# Site Plan Review File # 22-116-859

- **LOCATION:** 0 Madison St. (N of 2319 W 7<sup>th</sup> St. and St. Paul Avenue)
- **APPLICANT:** Trellis Treehouse Acquisition LLC
- **HEARING DATE:** December 1, 2022
- **DATE RECEIVED:** August 23, 2022
- **PLANNING COMMISSION DECISION:** December 9, 2022
- **DEADLINE FOR ACTION:** February 20, 2023

**C401**

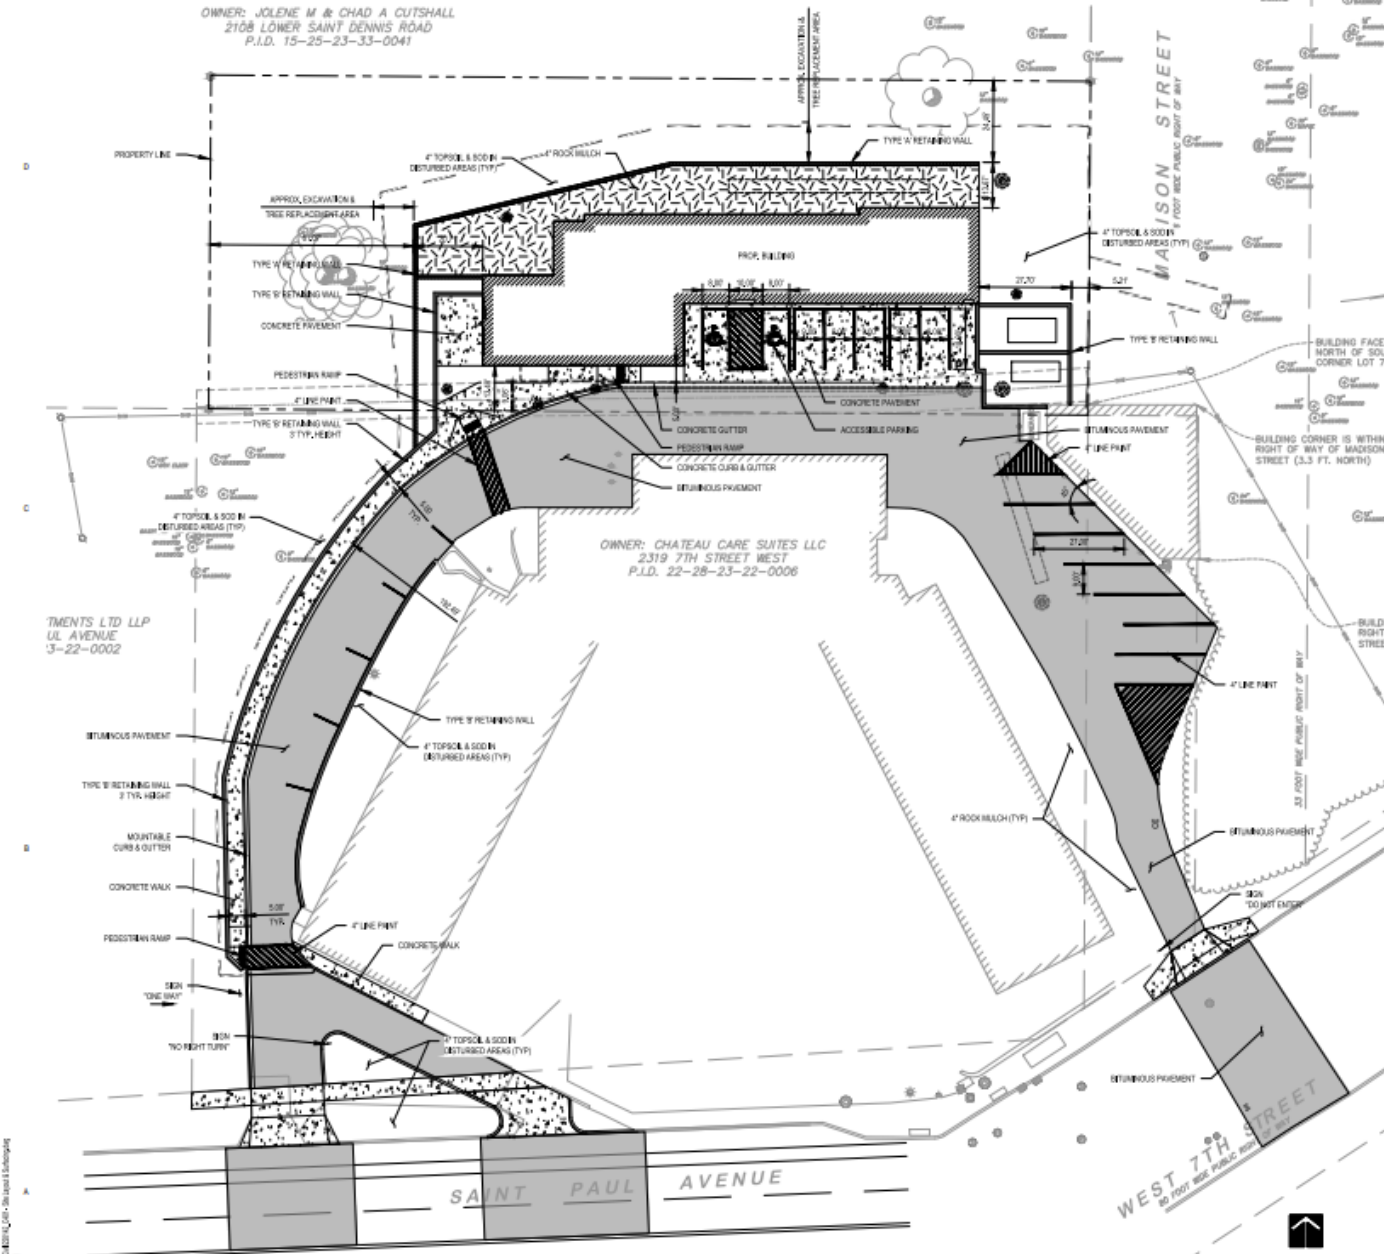
*Safety and convenience of both vehicular and pedestrian traffic both within the site and in relation to access streets, including traffic circulation features, the locations and design of entrances and exits and parking areas within the site.*

Physical improvements to the existing drive at Highland Chateau parcel provide access and public services via a private street with a reciprocal maintenance, use, and easement agreement. The existing one-way site circulation will continue with a vehicular entrance to the private street from West 7<sup>th</sup> Street and an exit onto St. Paul Avenue.

Improvements along the Highland Chateau's St Paul Avenue frontage are required per Public Works and Zoning to provide the safest possible scenario for all modes arriving at the site.

- The existing drive will become a private street.
- Widening the one-way access drive to give space for resident drop off, maneuvering isles, and trash pickup, emergency access etc.
- A public sidewalk added to the Highland Chateau parcel along St. Paul Ave.
- Sidewalk along St. Paul Ave. and the private drive will meet Minnesota Accessibility code
- Removal of existing encroachments in the ROW
- Minimize curb cuts and meet Public Works' standards for curb and driveway design.
- Room for passenger drop off will remain at the Chateau.

A traffic memo is under review by Public Works Traffic Engineering. Public Works sign-off of the site plan and acceptance of the traffic memo are recommended conditions of site plan approval.

# Red, green and blue areas draining to Stormwater Management System.

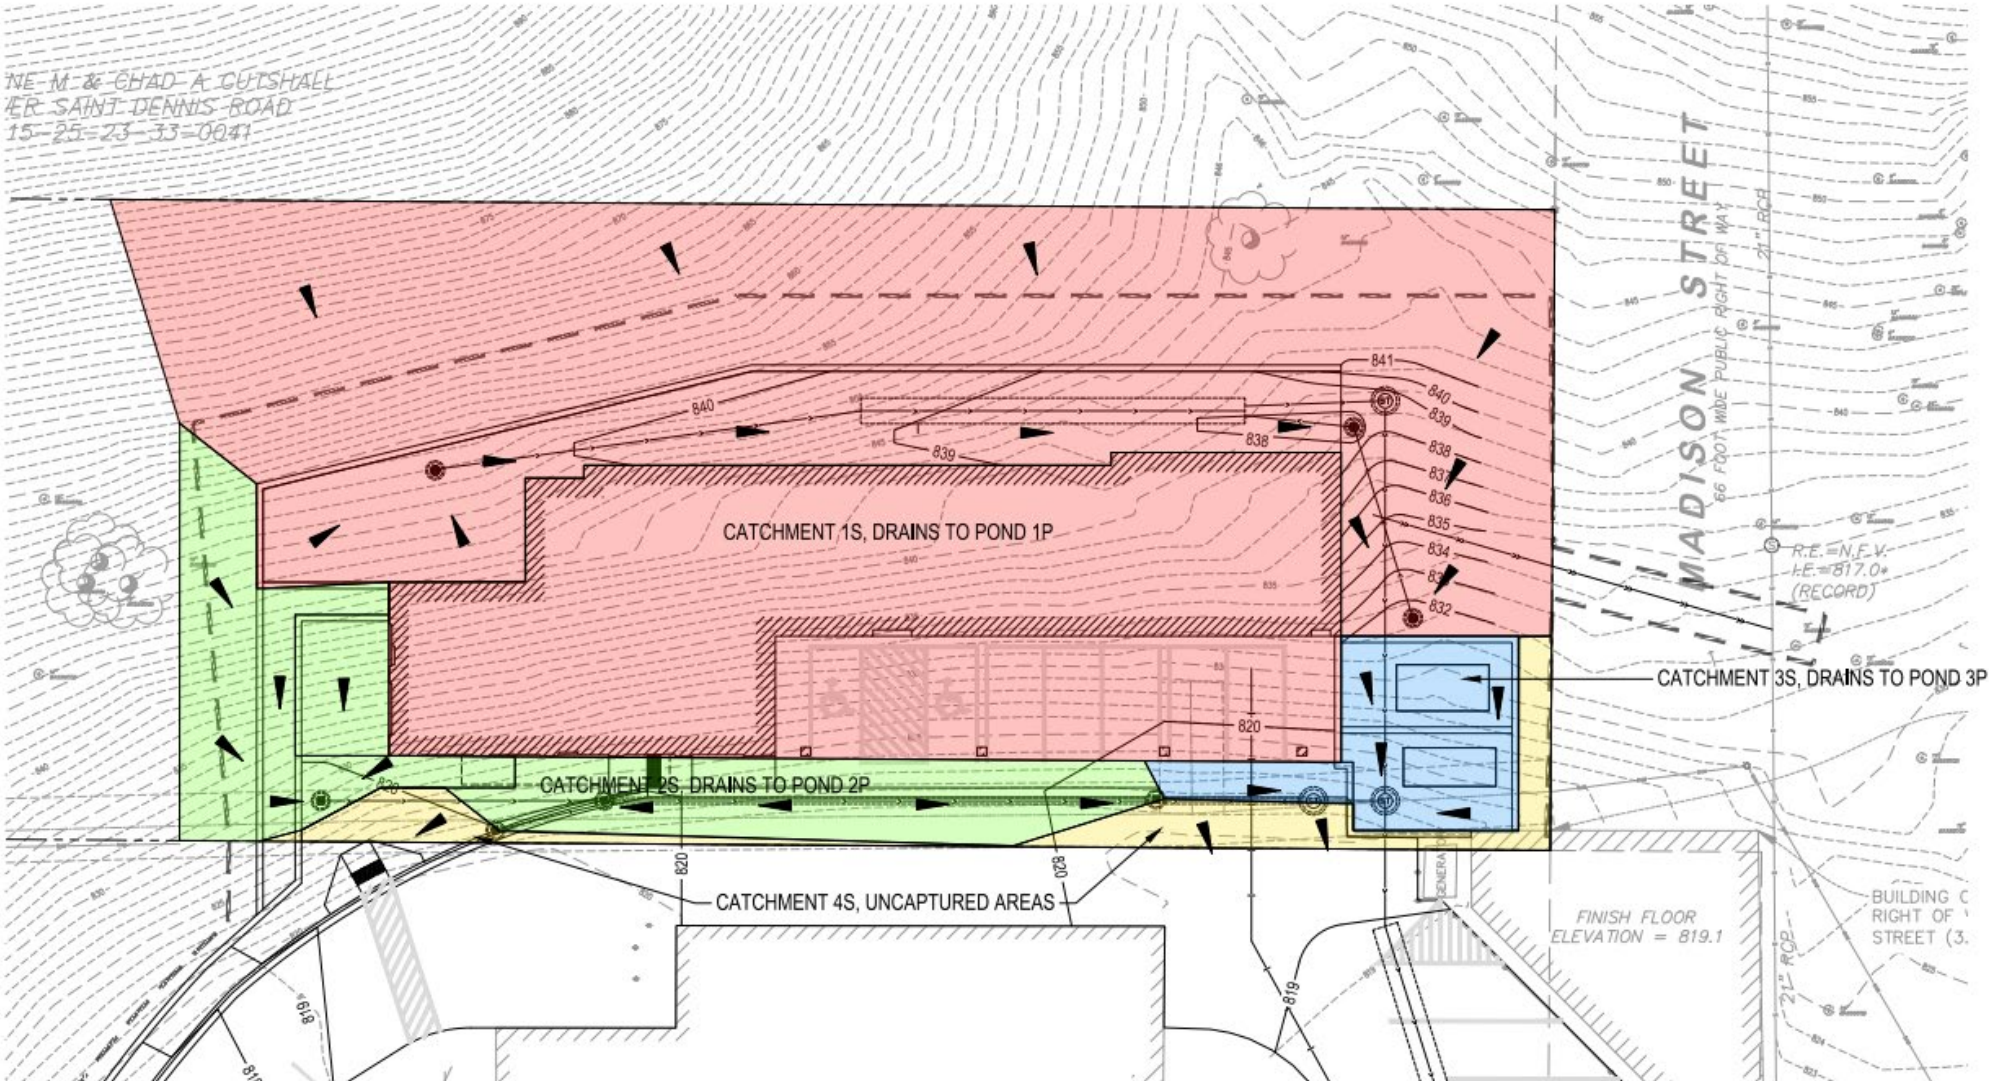
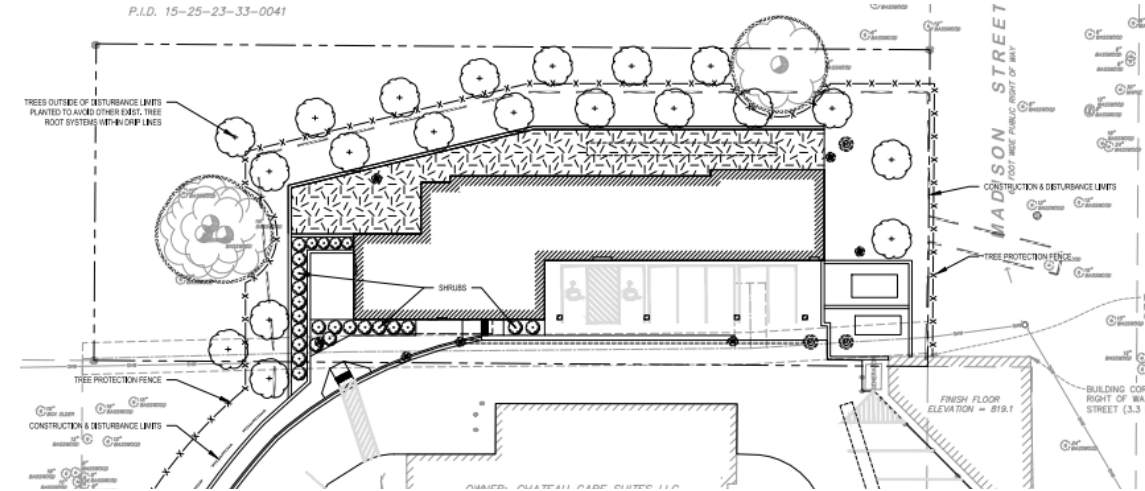
The following conditions relate to development on a steep slope:

- The specified elements of the required engineering report on slope stability and hydrology per § 63.111(a)(1-3) must be submitted to the City for review and acceptance before any permits will be issued, including grading permits. The findings in the engineering report may result in required revisions to project plans as determined by Department of Safety and Inspections staff. If revisions to project plans are required as a result of the engineering report, these revisions to plans must be made to all plans submitted to the City for approval before any permits will be issued, including grading permits.

- That the City Forester accept the Landscape and Tree Preservation Plans for the post construction establishment of trees and vegetation on this slope.

- Lastly, all final slopes must be immediately stabilized to prevent erosion. Trees must be planted, and all disturbed soils on the slope must be adequately covered with a suitable topsoil and seeded per Minnesota Board of Water and Soil Resources specifications for native vegetation establishment.
